2016 Corvette: Service Bulletin: Delayed Engagement After Sitting With Engine Off

#16-NA-014: Delayed Engagement After Sitting With Engine Off - (Jan 21, 2016)

Subject: Delayed Engagement After Sitting With Engine Off

- (A) Old stator support asm 242
74636/24275106/2427265
6
- (B) New stator support asm
24277234

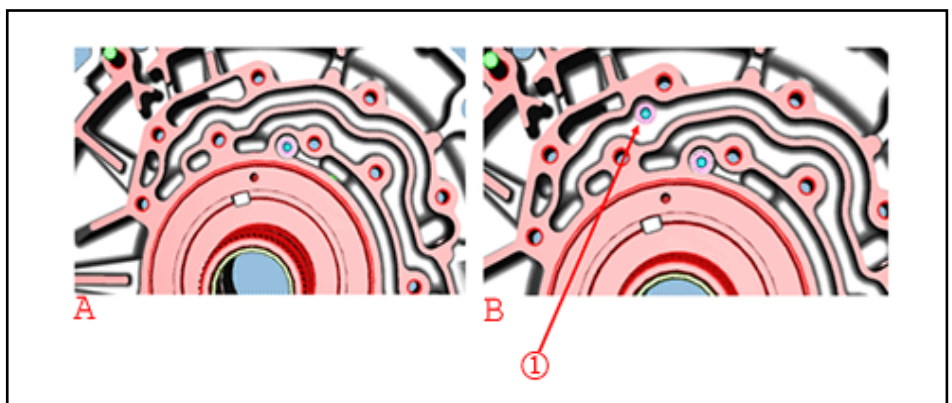
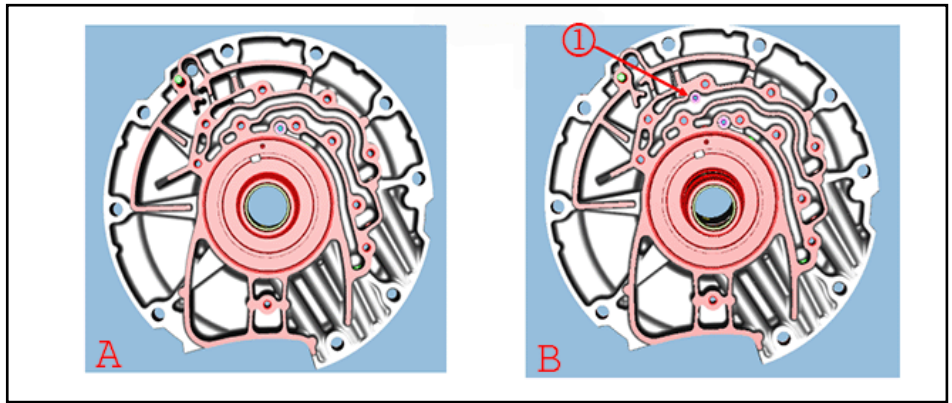
Note: The new stator shaft support assembly has a second check ball (1) added (see illustrations).

Install a new stator shaft support assembly that includes an additional check ball. Follow the instructions below to replace the stator shaft support assembly.

Old cover 24272660

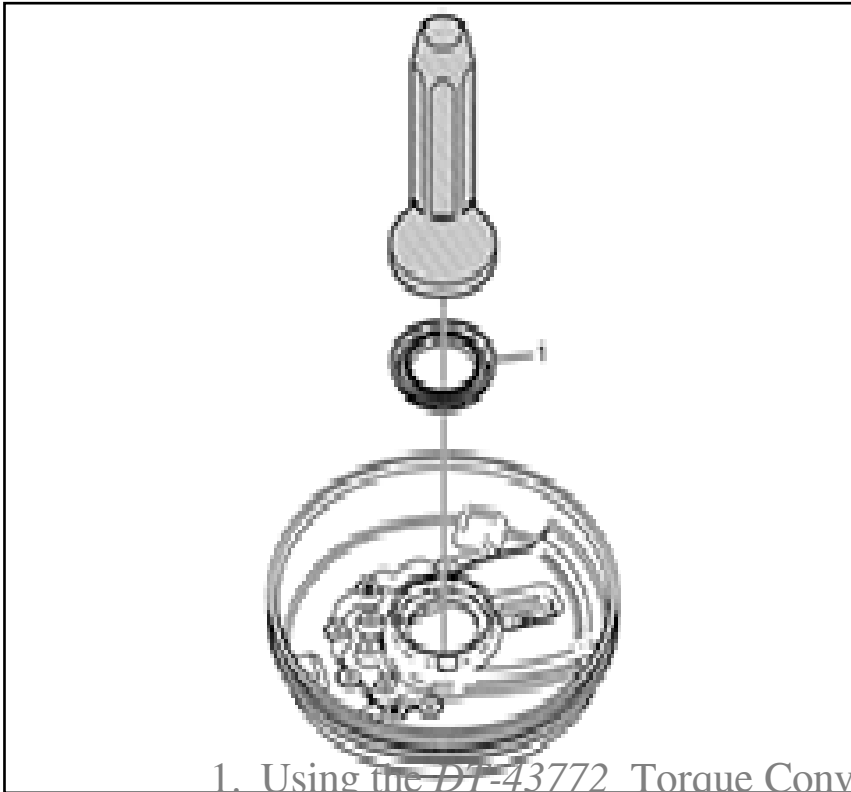
Note: The casting void has been eliminated from the underside of the cover (see illustration).
